800GbE Logic Skew

IEEE P802.3df Logic ad hoc
February 21, 2023

Mark Gustlin – Cisco

SP1 View

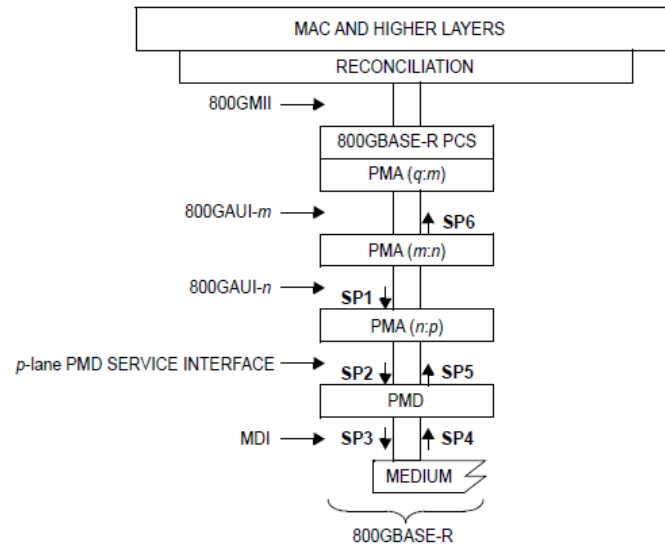
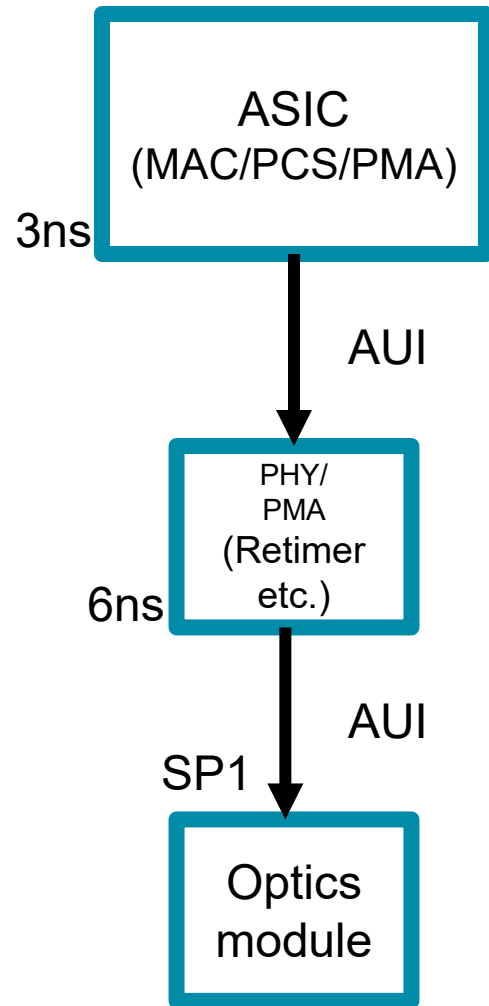
- SP1 has multiple possible components:
 - Skew from a large ASIC
 - Skew from a PHY type device (if used)
 - PCB board skew

- ASIC contribution could be up to 3ns in the worst case for devices I surveyed
- PHY contribution is up to 6ns for devices I surveyed
 - If the PHY is just a retimer than it adds to the budget
 - If the PHY is a PCS/MAC/MACsec device, then the skew budget is reset at this point
- Board skew contribution
 - 2ns per 12" of PCB, allocate 6" of delta for a port? So assume 1ns?
 - This is pessimistic, but a small adder to the budget
- Total SP1 skew is ~10ns
- Think we should pad it by 5ns, so proposing 15ns total budget
 - Above skew is for a limited number of devices

Adee's proposed remedy:

| Skew point | Contributor | Maximum (PCS UI) | Cumulative (PCS UI) | Cumulative (ns) | Reason |
|------------|--------------------------------------|------------------|---------------------|--------------------|------------------------------|
| SP1 | Tx PCS/PMA and possible external PMA | 192 | =770 192 | 29 ≈7.2 | PCS/PMA Tx + PMA Rx + PMA Tx |

SP6 View

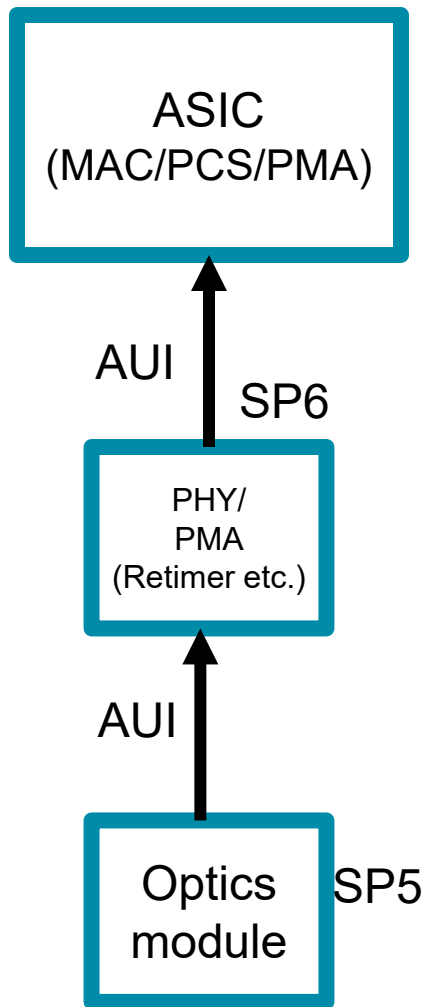
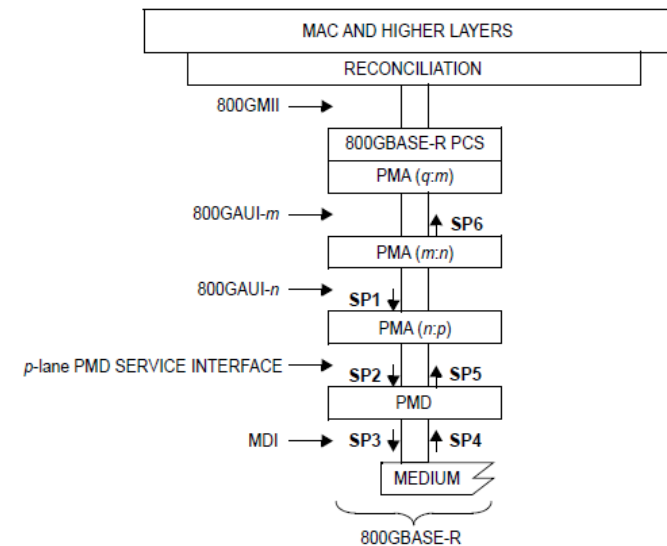
- PHY contribution is up to 6ns for devices I surveyed
 - If the PHY is just a retimer than it adds to the budget
 - If the PHY is a PCS/MAC/MACsec device, then the skew budget is reset at this point
- Board skew contribution
 - 2ns per 12" of PCB, allocate 6" of delta for a port?
 - So assume 1ns.
- Unaccounted for skew in the optical module PMA
- Total SP6 skew is ~7ns + optical PMA skew
- Assuming the optical PMA skew is a few ns worst case
- Think we should pad it by 5ns, so proposing 15ns total budget?
 - Above skew is for a limited number of devices
 - Could refine this once we know more about the PMA in the optical module

Adee's proposed remedy (9.6ns down from 15ns):

| SP5 | Module PMD Rx | 128 | ≈3852 1088 | 145 ≈41 | As in PMD Tx |
| SP6 | Module PMA and external PMA | 256 | ≈4250 1344 | 160 ≈50.6 | Two PMAs, each with Rx and Tx |

At PCS RX

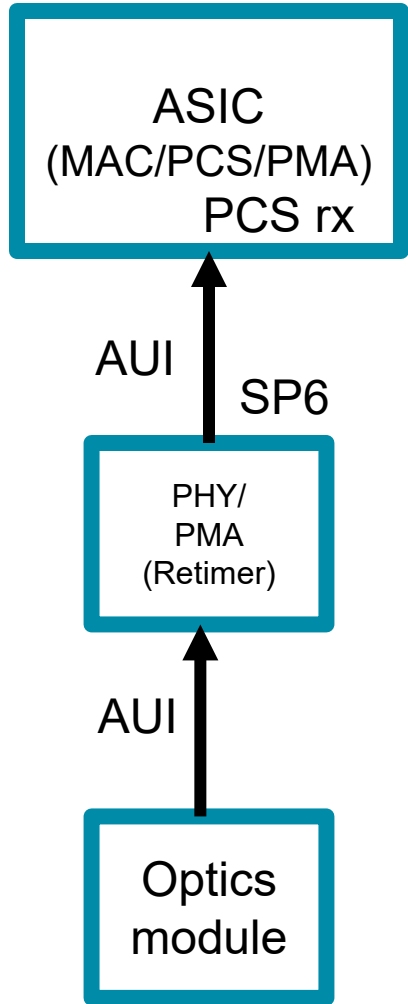
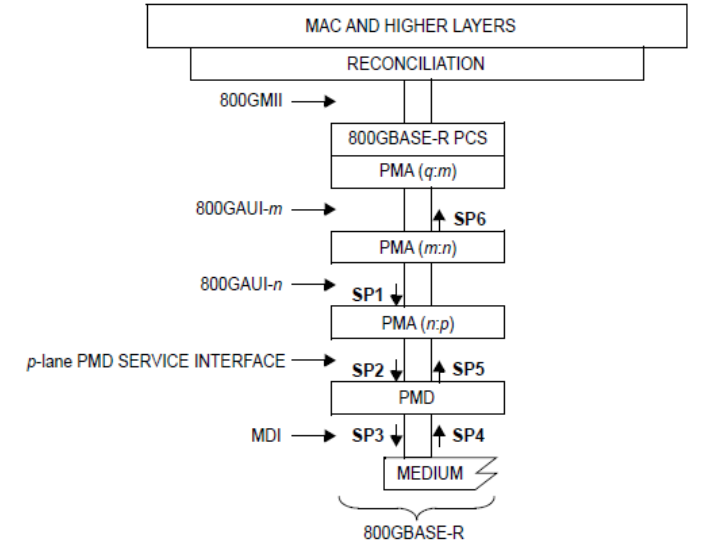
- ASIC Internal contribution
 - 3ns, same as SP1 contribution
- Board skew contribution
 - 2ns per 12" of PCB, allocate 6" of delta for a port?
 - So assume 1ns.
- Total PCS skew is 4ns
- Think we should pad it by 4ns, so proposing 8ns total budget
- You could make the case that we don't specify this at all since this contribution is all internal to the ASIC!

Adee's proposed remedy (2.4ns down from 20ns):

| SP6 | Module PMA and external PMA | 256 | 4250 1344 | 160 ≈50.6 | Two PMAs, each with Rx and Tx |
| PCS input | Rx PCS/PMA | 64 | 4781 1408 | 180 ≈53 | PMA Rx |
